**TOWN OF NEWBURGH
PLANNING BOARD
TECHNICAL REVIEW COMMENTS**

PROJECT NAME: FAC SELF STORAGE/UHAUL-MIDDLEHOPE
PROJECT NO.: 21-33
PROJECT LOCATION: SECTION 20, BLOCK 2, LOT 2
REVIEW DATE: 13 MAY 2022
MEETING DATE: 19 MAY 2022
PROJECT REPRESENTATIVE: MECURIO-NORTON-TAROLLI-MARSHALL, ENGINEERING & LAND SURVEYING/LARRY MARSHALL

Re: Job No. 4762
Lands of Five SAC Self-Storage Corp
Tax Parcel: 20-2-2
5325 NYS Route 9W
Town of Newburgh
Commercial Site Plan
Newburgh Project No. 2021-33

Subsurface Infiltration Basin "1" Detail
NOT TO SCALE

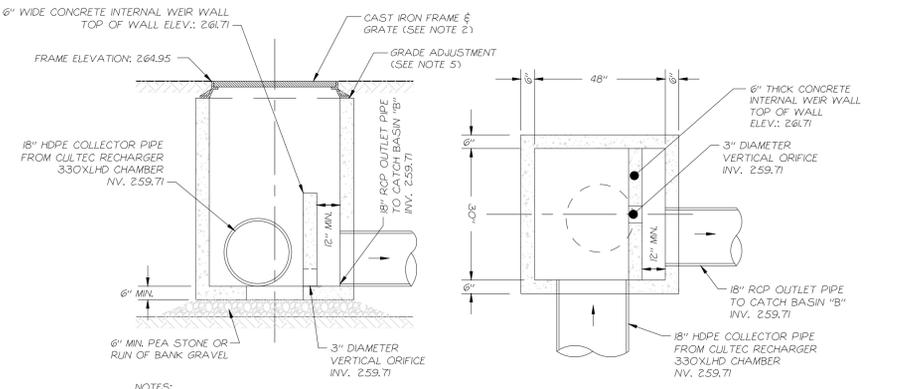
1. Additional soil testing is being performed in the infiltration basin to comply with DEC Stormwater Design Manual. Information regarding the 2" per hour exfiltration must be confirmed.

- 6) THE SUBSURFACE INFILTRATION BASIN HAS BEEN DESIGNED WITH AN INFILTRATION RATE OF 2.0 INCHES PER HOUR BASED UPON THE PRELIMINARY SOILS TESTING COMPLETED IN THE SYSTEM AREA. THE SYSTEM AREA SHALL BE PROTECTED DURING CONSTRUCTION AND CARE SHALL BE TAKEN TO AVOID COMPACTION OF THE EXISTING SOILS AT OR BELOW THE BASE ELEVATION OF THE SYSTEM. RUNOFF SHALL NOT BE DIVERTED INTO THE SYSTEM UNTIL ALL TRIBUTARY DRAINAGE AREAS HAVE BEEN STABILIZED.

Typical Trench Drain Detail
NOT TO SCALE

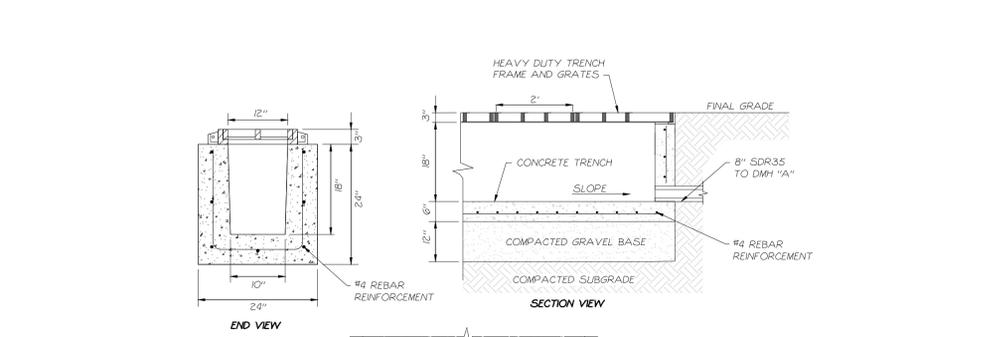
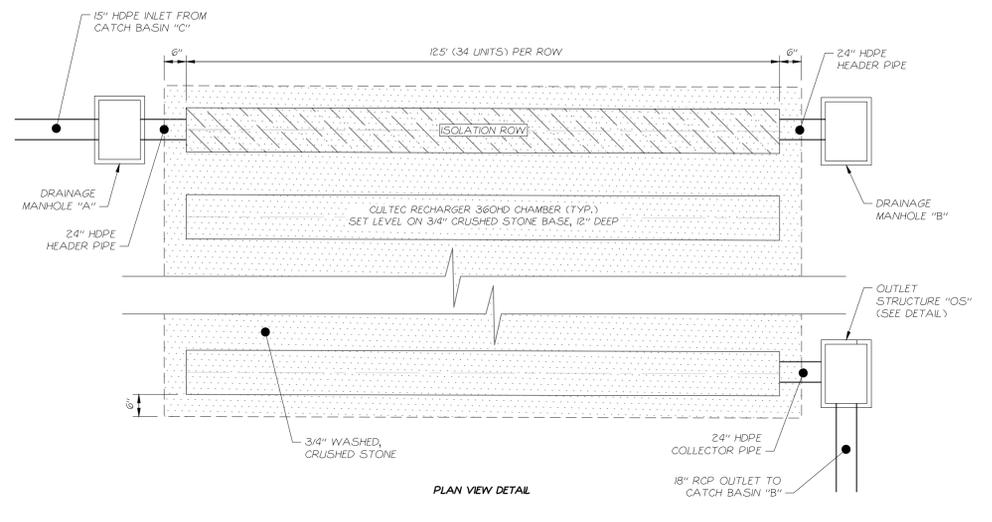
6. The applicant's representative are requested to evaluate the trench drain now proposed at the access drive. An 8" discharge pipe is identified. A large portion of the parking lot will discharge to the trench drain based on current grading.
